Independent review

Fyshwick Materials Recycling Facility

Environmental impact statement

Report | 271672-00 - FYS - RPT - 000001

Figure 1: Proposal overview

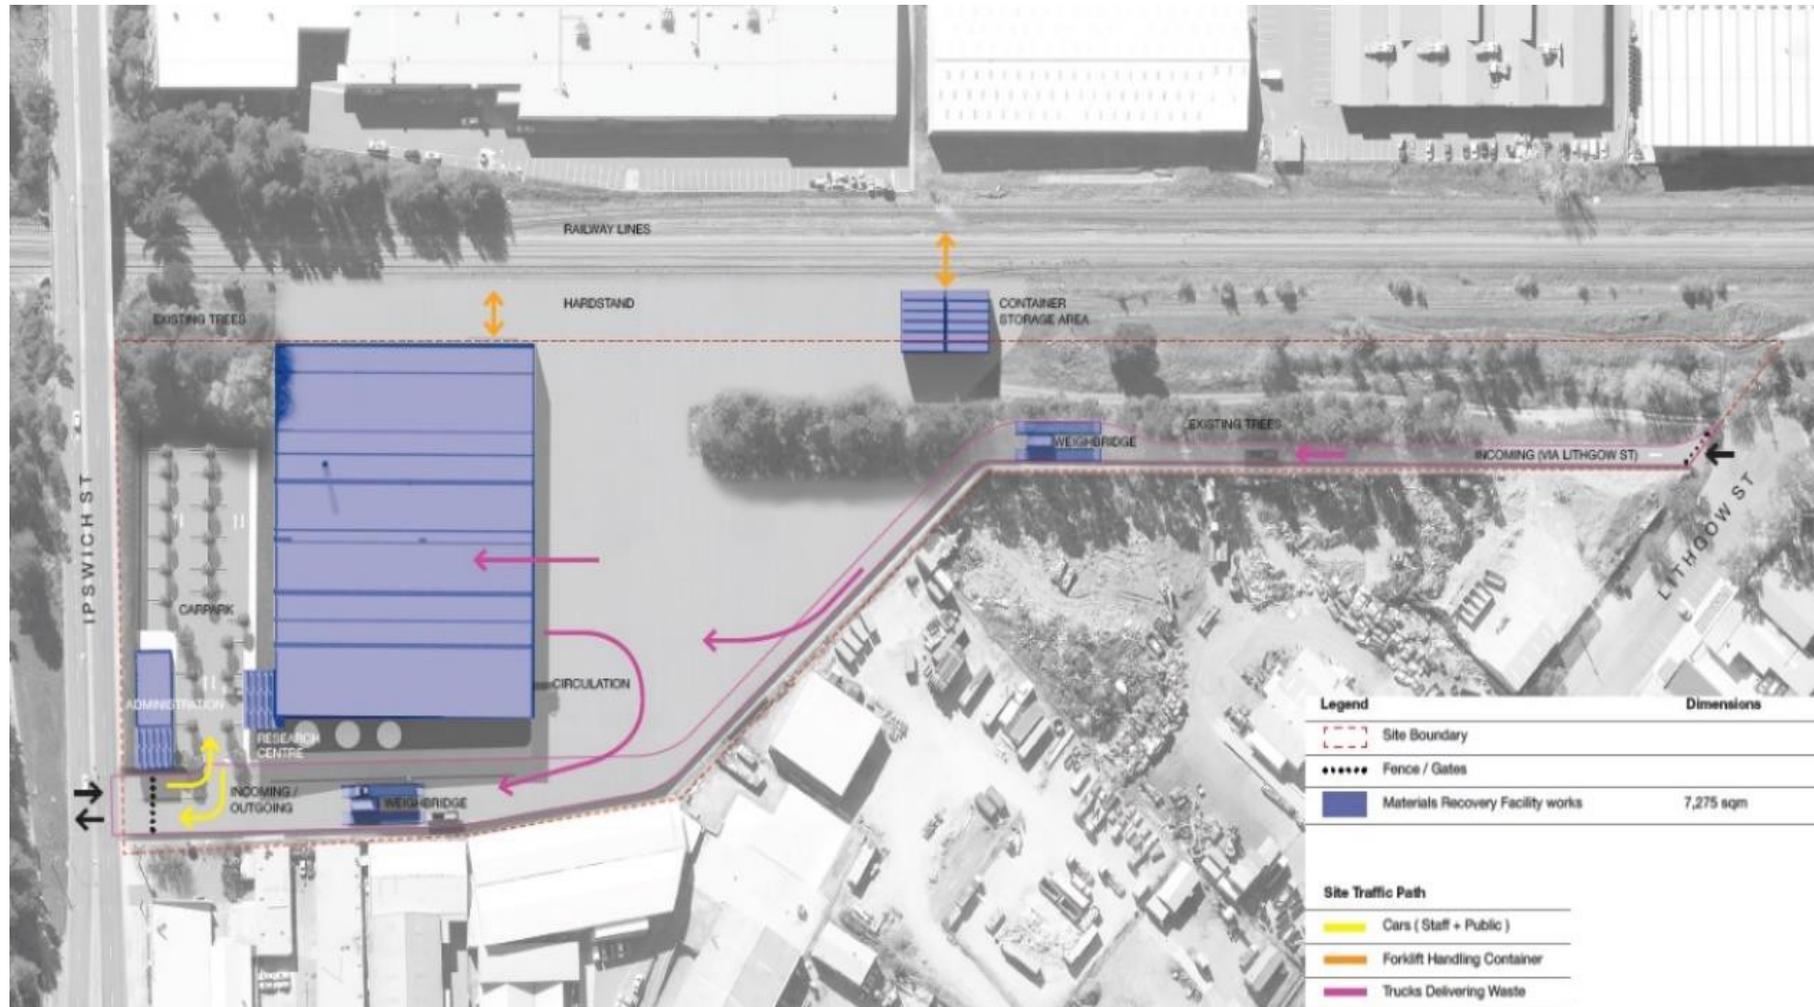
The containers would be stacked close to the rail freight terminal (refer to **Figure 1**). No more than three containers would be stacked on top of each other. The containers stored outside of the building would be transported by rail to the landfill every day. There is no information on whether the storage area would be banded or covered.

There appears to be little information on the final landscape planting strategy, other than the intention to retain two areas of existing vegetation as shown on **Figure 1**.
